TRUSS LAYOUT/SUBMITTAL REVIEW

JOB No.	2720415
DESCRIPTION	Roesser - Innis Res - 1483 Winterset Valley
JOB ADDRESS	3057 NW Thoreau Lane
CITY	Lee's Summit, MO
DESIGNER	SCOTT CLEVELER
DATE	3/18/2021

ROOF
TRUSS LAYOUT

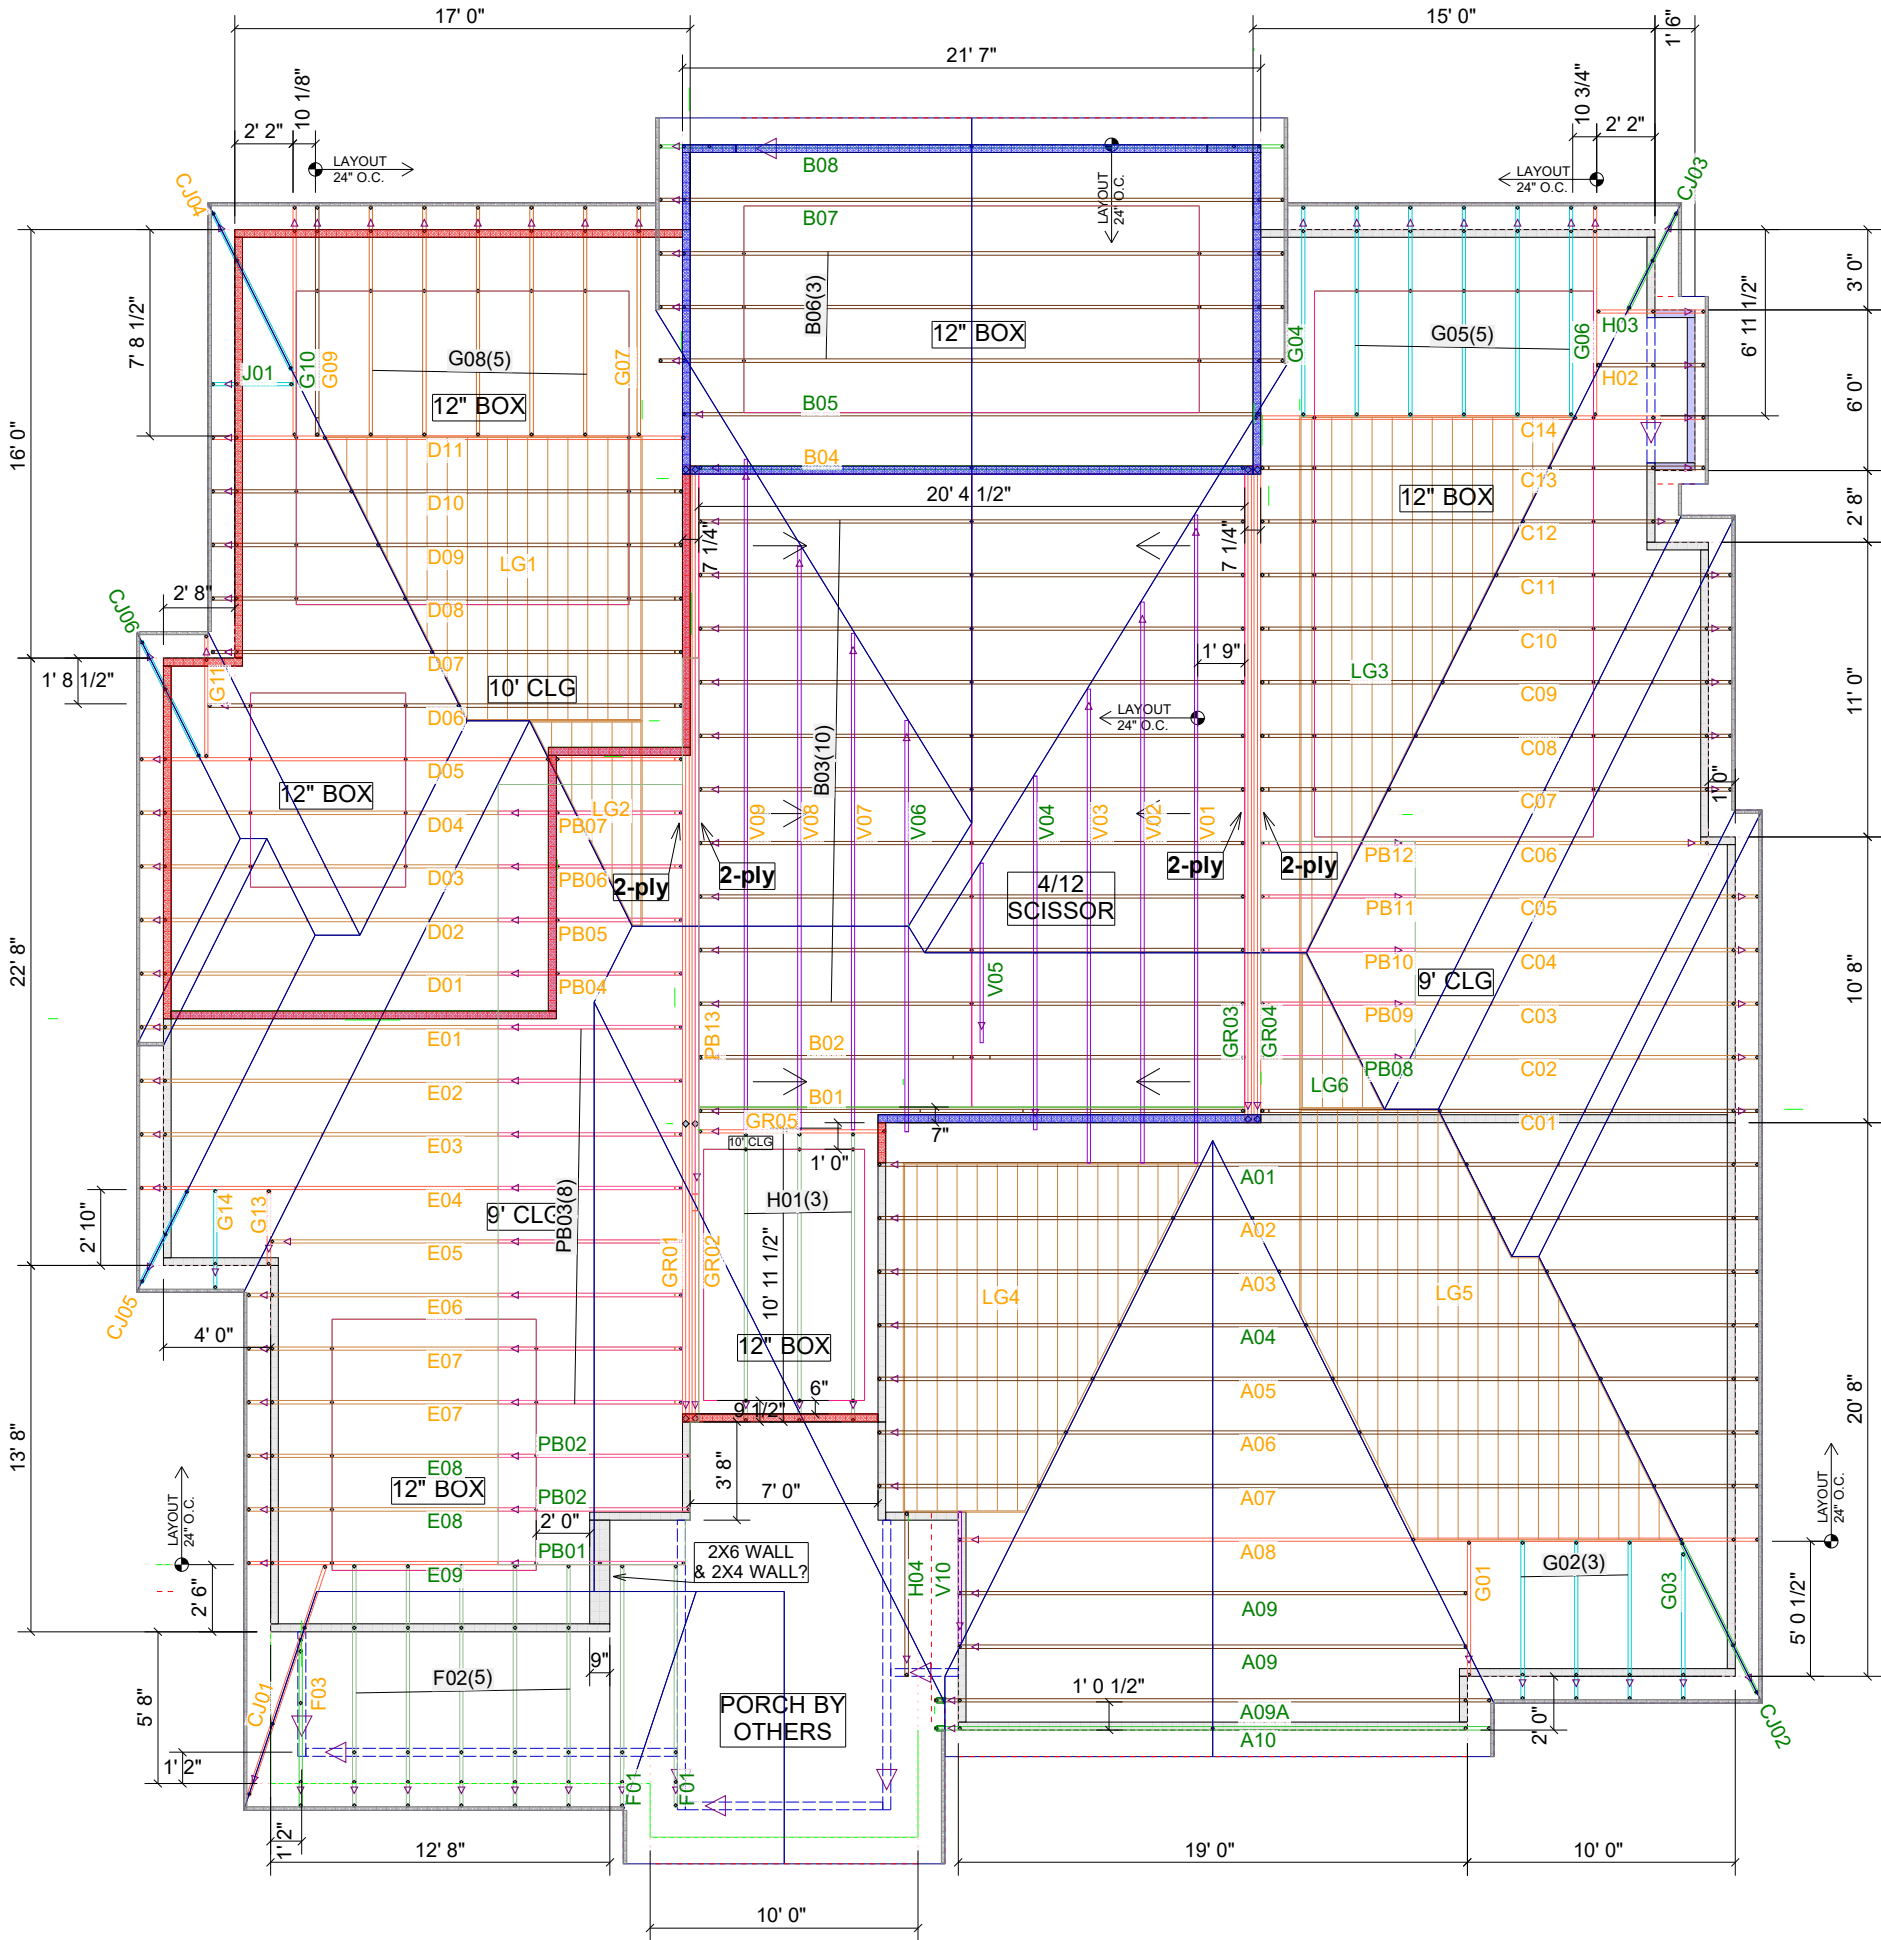
- ☒ REVIEWED & FOUND TO BE IN CONFORMANCE WITH REFERENCED PLAN
- ☐ FURNISH AS CORRECTED
- ☐ REVIEWED WITH CHANGES TO REFERENCED DRAWINGS
- ☐ REVISE AS NOTED & RESUBMIT
